STUDIO PLUS #8570

Venture Oaks Way
Sacramento, California

A Commercial Project for
Extended Stay America

DATE: 4/20/98
TO: Taiwo Jaiyeoba, Planning – North Team
FROM: Fritz Buchman, Jr. Engineer, Development Services 
RE: EXTENDED STAY AMERICA (P98-028)

SITE PLAN

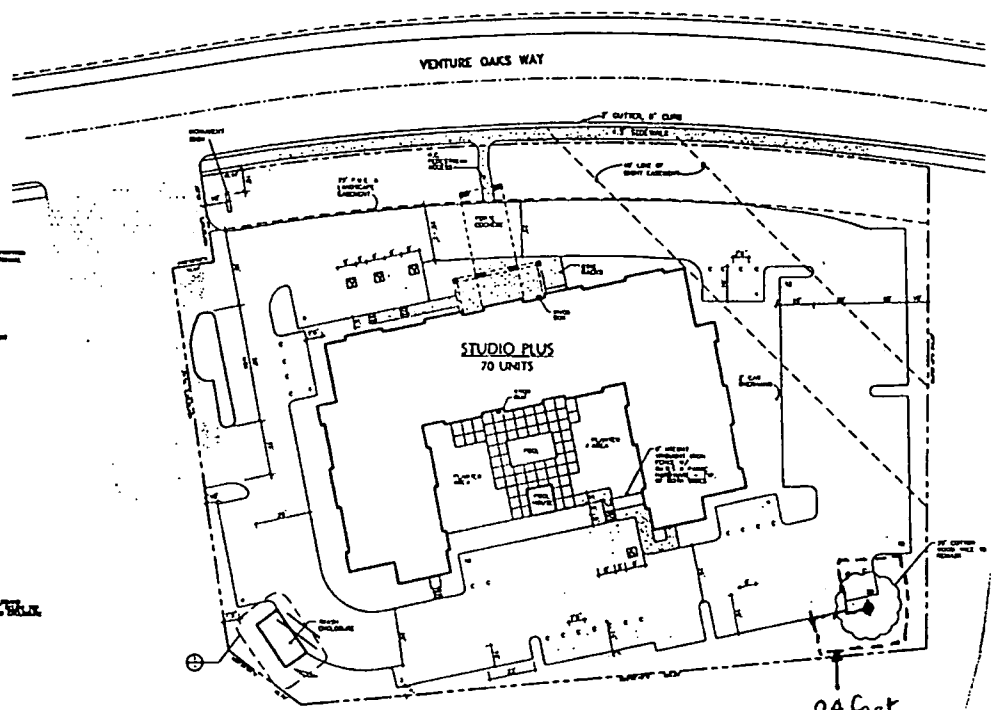
- The driveway shall be to City Standards. Provide standard driveway flares. If the driveway will be two-way, the maximum width is 35'. For a one-way driveway couplet separated by an island, the maximum width is 67' (25'-17'-25'). For the one-way case, show island detail and any curb on the side away from the site.

- Provide a minimum 25' of throat distance behind the driveway. The throat area should be clear of any parking aisles or spaces. This will require reconfiguration of the curb in front of the building leading to the driveway area.
- The curb island separating the site accesses shall be a minimum of 50' long. The opening for the site access nearest Venture Oaks shall be a maximum of 35' wide. Only one site access is required; however, if an additional access is desired, its opening shall be a maximum of 25' wide.

- Site access will be limited to the Parcel 4 easement area behind the curb island near the driveway (as presently shown). The site access opening shall be a maximum of 35' wide.
- Monument sign must be located 10' from driveway, 10' behind RW, and allow stopping sight distance per CalTrans standards, per the Sign Ordinance.
- Provide 26' maneuvering distance behind all standard and handicap parking stalls (this can be achieved for the handicap stalls nearest Venture Oaks by shortening them to 18'). Lengthen the 16' standard stalls shown on the south side of the site adjacent to the building to 18'.
- Show the existing tree on the easterly corner of the site and indicate the intention to preserve it.

- Submit a revised site plan prior to conditioning for this project.
- Check all handicap ramps, handicap parking spaces, and accessible paths for compliance with ADA requirements.

- The driveway from Venture Oaks Way shall comply with City standards and have a maximum width of 35'.
- Repair or replace any deteriorated curb, gutter, and sidewalk along the Venture Oaks Way frontage to the satisfaction of the Department of Public Works.
- The applicant shall coordinate with Public Works staff to modify street lighting along Venture Oaks Way, as required to accommodate the project.
- Remove the two compact parking spaces adjacent to the tree near the easterly corner of the site, as requested by the City Arborist.

ATTACHMENT J: TREE EXHIBIT AND COMMENT

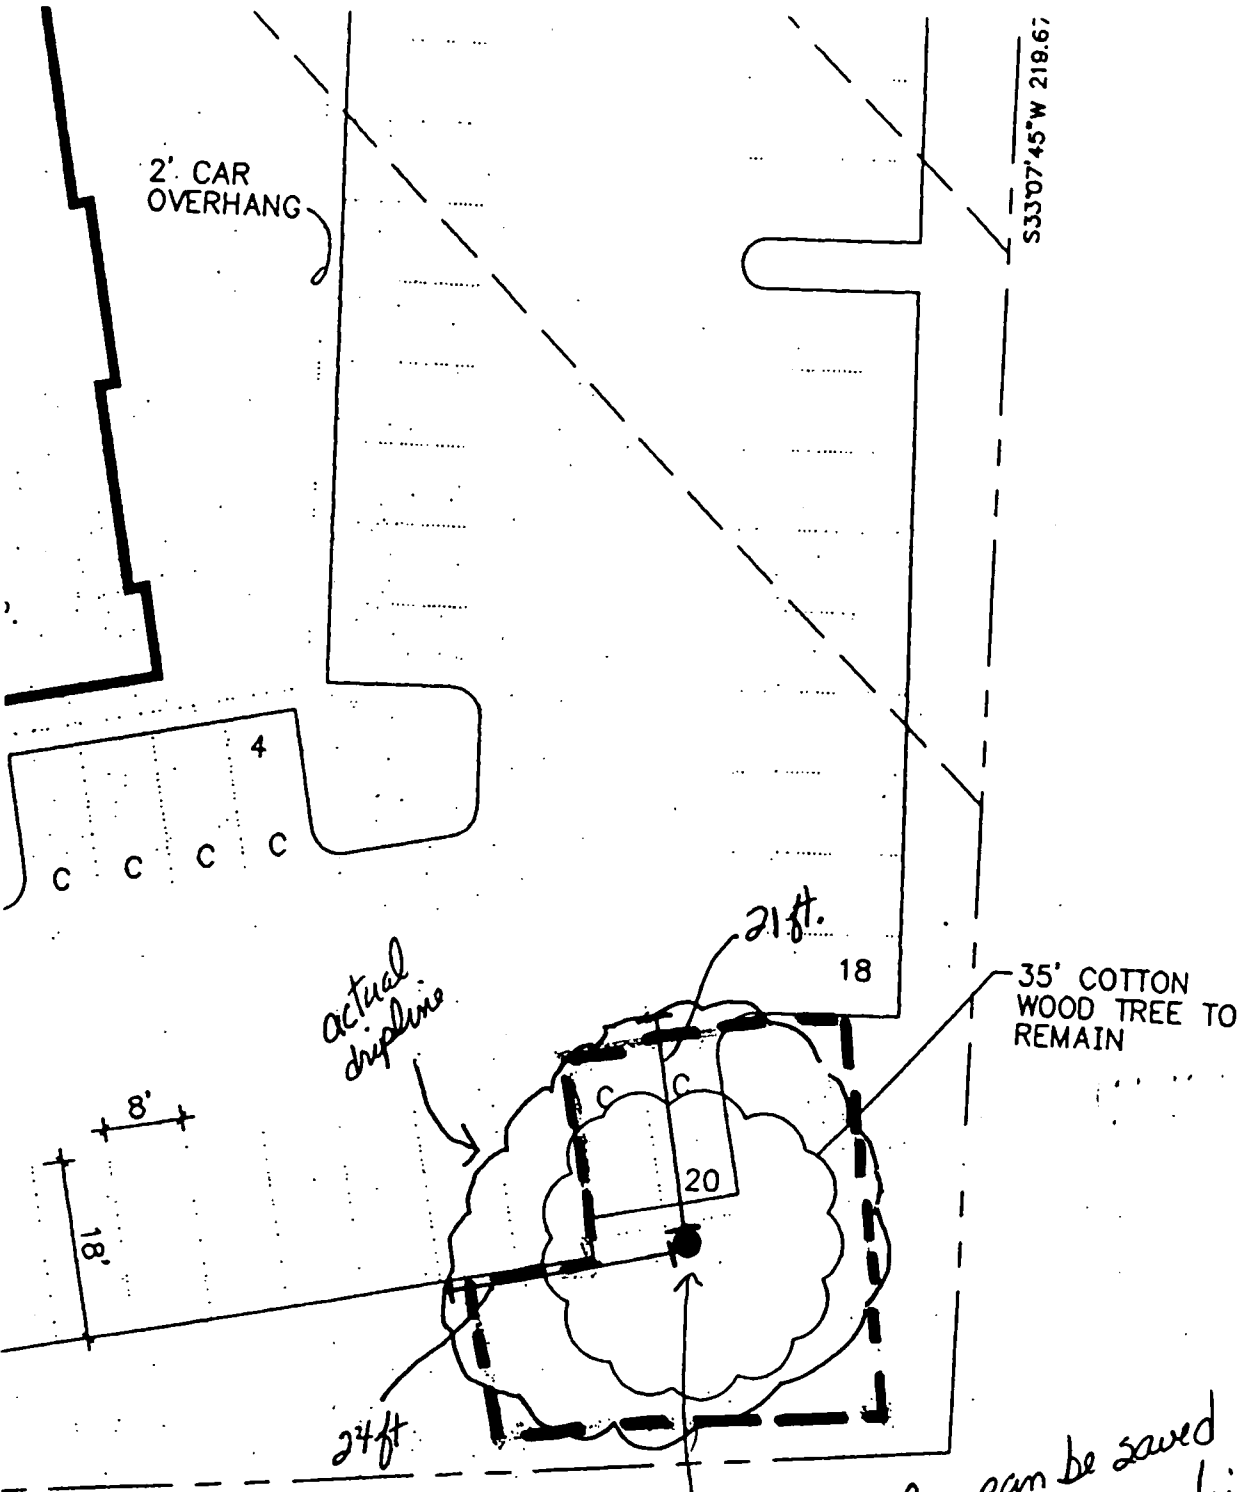
33.5" Fremont Poplar can be saved
or removed at developer's discretion
Dan PsKowski - City Arborist
6-12-98 768-8604
